**EPRI Responses to NRC Request for Additional Information  
on Addenda 3, 4, 5, 6 and 7 to EPRI TR-103237-R2, *EPRI MOV  
Performance Prediction Program – Topical Report***

**Figure 1 - Predicted versus Measured Unwedge Thrust**

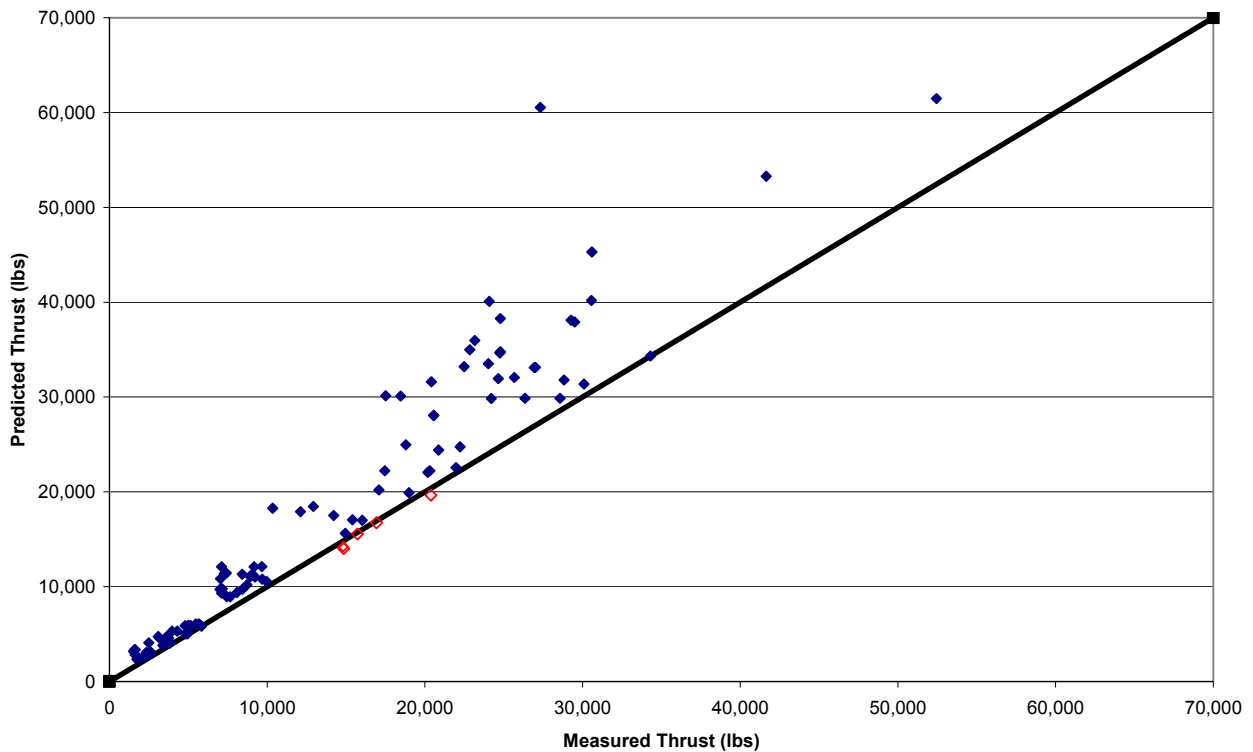
The unwedging thrust model discussed in Addendum 3, "An Improved and Validated Gate Valve Unwedging Methodology" (TR-113564, December 1999), to the Electric Power Research Institute (EPRI) TR-103237-R2, "EPRI MOV Performance Prediction Program," uses a minimum static unwedging thrust observed from plant testing. Accordingly, a plant could perform multiple static unwedging tests and then use the lowest measured static unwedging thrust as input to the model to estimate a dynamic unwedging thrust. Provide additional justification for using a single potentially nonconservative static unwedging thrust in the unwedging thrust model.

For validation of the improved unwedging methodology (Appendix A of Addendum 3), the minimum static unwedging thrust for each valve was used. This approach was used to be conservative; in other words, if predictions based on the minimum unwedging thrust are bounding, then the method itself is certain to be bounding.

Figure 1 shows a comparison of predicted unwedging thrust versus measured unwedging thrust for the 107 strokes included in *Method Validation* in Addendum 3. As shown in the figure, the refined unwedging methodology predicted bounding values of dynamic unwedging thrust for 102 of 107 strokes. Further, the underpredictions (shown as open points in the figure) are small.

These favorable results were achieved using the minimum measured static unwedging thrust for each valve. When plants apply the method, their approach is to use the "test stroke" for each valve, which is a stroke pre-designated for data collection. If there is a range of unwedging thrusts that can occur for the valve, then the "test stroke" value, on a probabilistic basis, will be in the range between the minimum and maximum values. As the method validation was performed using the minimum value, use of the "test stroke" value will yield a result that tends to be more conservative than that predicted in the Addendum 3 validation.

Figure 9A - Stem COF at Unwedging versus Thread Pressure

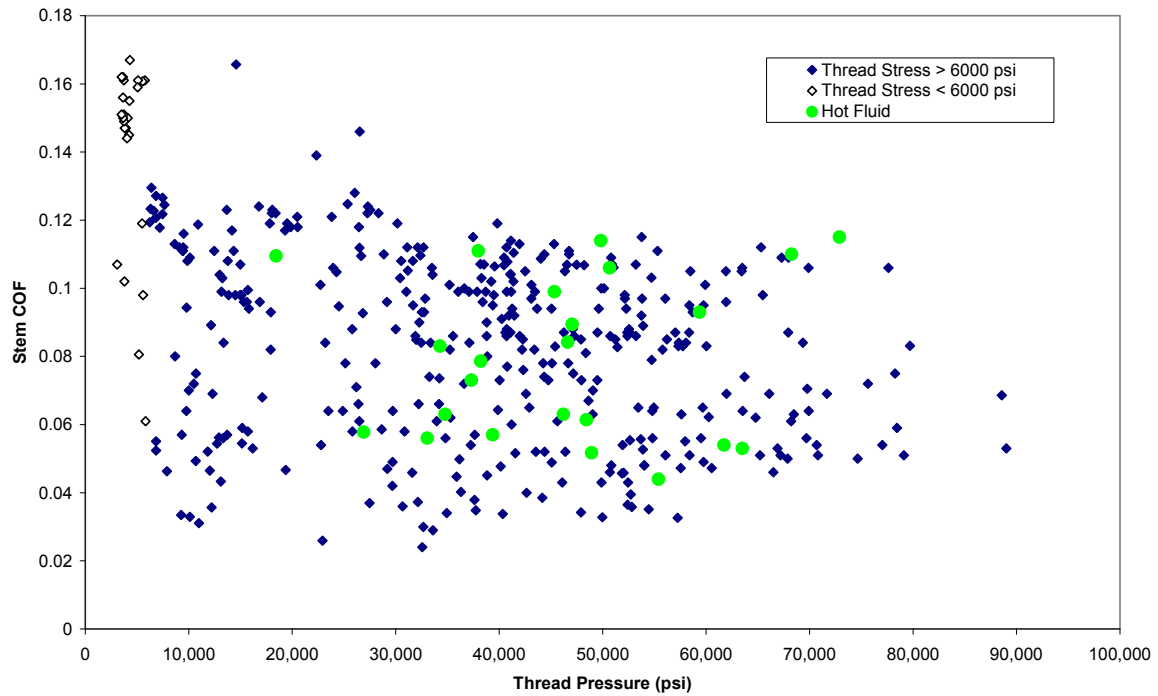
The test data used to evaluate the proposed unwedging stem nut coefficient of friction model proposed in Addendum 4, "Use of Static Closure Data for Determining the Stem-to-Stem Nut Coefficient of Friction at Unwedging" (TR-113989, December 1999), to EPRI TR-103237-R2 was performed at ambient conditions. Past research has shown that lubricating characteristics can change at elevated temperature, resulting in changes in the stem coefficient of friction. Provide justification for applying the model to stems and stem nuts that are at elevated temperatures, or clarify the applicability of the model to stems and stem nuts at ambient temperature.

With regard to the Population Analysis described in Addendum 4, Figure 9A (adapted from Figure 2-1 of Addendum 4) shows the distribution of stem-to-stem nut COF data at unwedging from the hot test sequences along with the other results at low temperature. As shown in the plot, no trend or particular effect is evident for the unwedging COF data from hot test sequences in comparison to the COF data from ambient test sequences.
